**An Coimisiún Pleanála Case reference: PL04.322787**

**Planning Authority Case Reference: 245503**

**Description**

Construction and decommissioning of 9 wind turbines and all associated site works.  
The Environmental Impact Assessment Report (EIAR) and Natura Impact Statement  
(NIS) was submitted to the Planning Authority with the application.

Figure 13

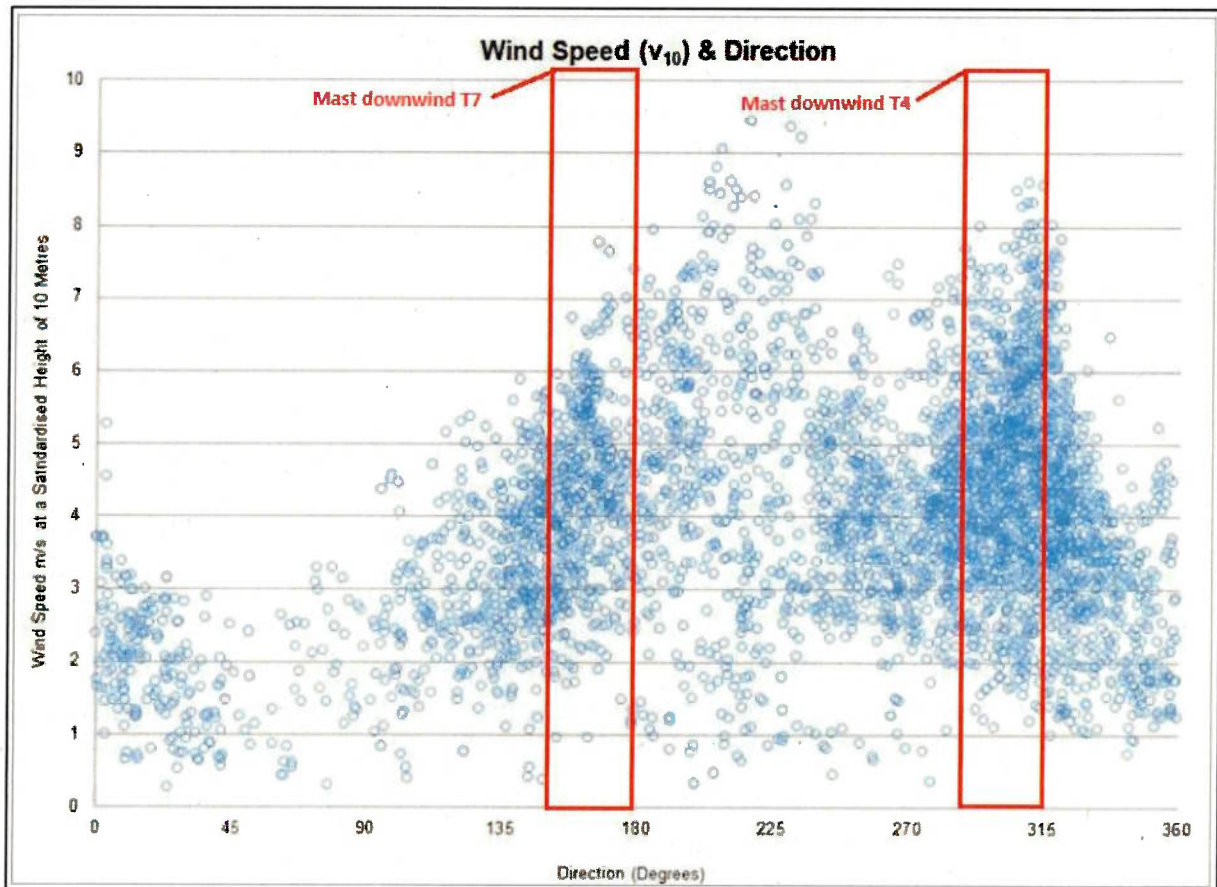
In addition to the extremely tight layout, the proposed siting of the permanent met mast is particularly poor. The applicant's own wind monitoring survey<sup>19</sup> shows the predominant prevailing wind direction is ~north westerly, roughly ~280° to ~325°, (figure 13). But directly upwind from the proposed met mast siting in that very direction, T4 is positioned a mere ~230 metres away with T3, also in that exact

direction, only ~400 metres behind T4. This means the met mast will experience a double wake effect from both T4 and T3 in the predominant prevailing wind direction with T4 only ~ 1.5 rotor diameters away. I strongly contend that due to significant turbulence and inherent loss of energy in the oncoming wind in the immediate wake of two turbines, met mast measurements from this crucial wind direction will not be reliable.

EIAR wind speed and direction graph showing Mast directly downwind of T4 in predominant NW wind direction and Mast directly downwind T7 in significant S-SE wind direction

Figure 14  
(EIAR figure 13. 13: BN3 Night-time periods  
with Noise Floor at ~16dB added as red line)

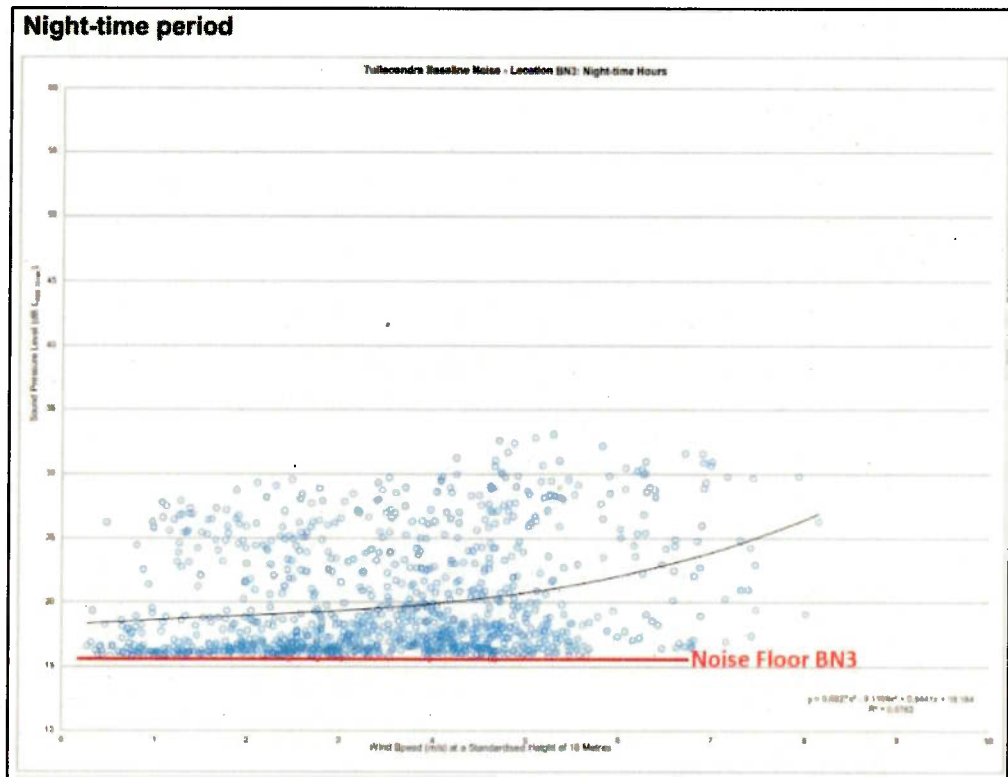
- c. The EIR details of the monitoring equipment used is incomplete. At every location a Brüel and Kjaer 2250 sound monitor was used but no details are provided in terms of the microphones or wind shields used. Neither are there any details of sound meter calibration. This is important because, the results across the four monitoring locations are not consistent. The noise floor<sup>20</sup> of the Brüel and Kjaer 2250 sound meter is around ~16dB and the nighttime results for BN2 & BN3 reach this value (as figure 14 shows for BN3). What is inconsistent is the noise floor for nighttime noise at BN1 at around 20dB and in particular, BN4, higher again at ~22dB (figure 15 which

shows the nighttime results for BN4) even though the sound monitors used were the same at all locations. When the two graphs are overlaid with each other the noise floor difference of ~6dB is striking (figure 16 showing nighttime results for BN4 with BN3 results overlaid).

Figure 16  
(EIAR figure 13. 13 & figure 13:15 overlaid with each other with  
Noise Floor added for BN3 ~16dB and BN4 ~22dB as red lines)

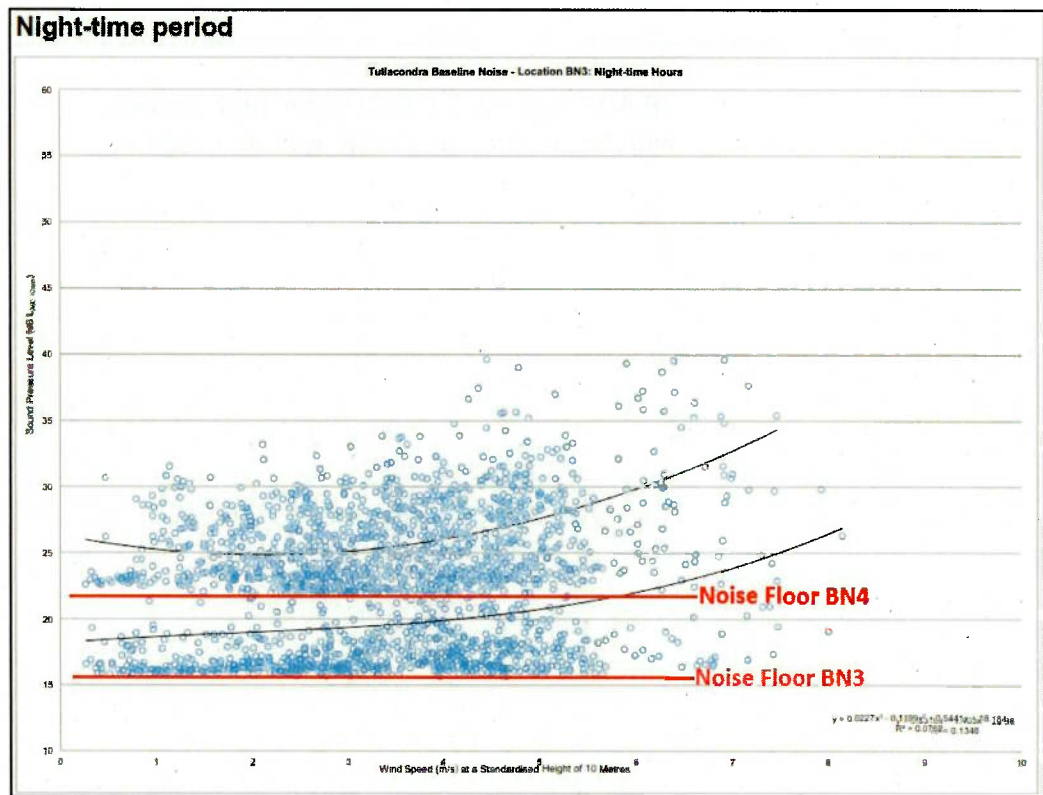
Because of the EIAR's general lack of detail around such items as the wind shields and microphones used, their calibration details and the poor photographs provided, it is difficult to reconcile these monitoring inconsistencies. It could, of course be that BN4 is a noisier location than BN2 or BN3 but the latter are nearer busier roads and from my local knowledge I would expect the noise results for all four locations to be broadly similar. And this is not the case with BN4 especially looking like an outlier.

Figure 17  
EIAR derived daytime background noise results graphed

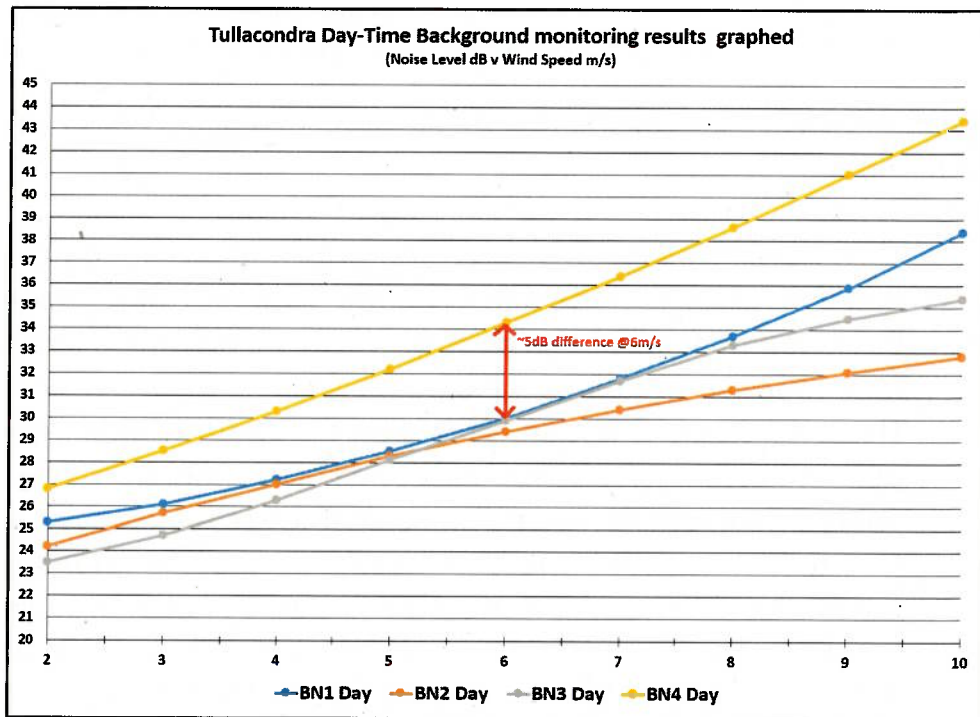
Graphing the monitoring results of derived background noise levels taken from Table 13.9 in the EIAR (titled Summary of baseline background sound levels, dB), it can be seen in figures 17 & 18 that there is reasonable correlation between BN2 & BN3 and to a lesser extent between them and BN1. However, BN4, which as explained earlier has the highest noise floor gives consistently higher derived results, always ~5dB to ~6dB greater than the other monitors. The analysis, strongly suggests that the BN4 derived results are out of line, are artificially high and may not be accurate.
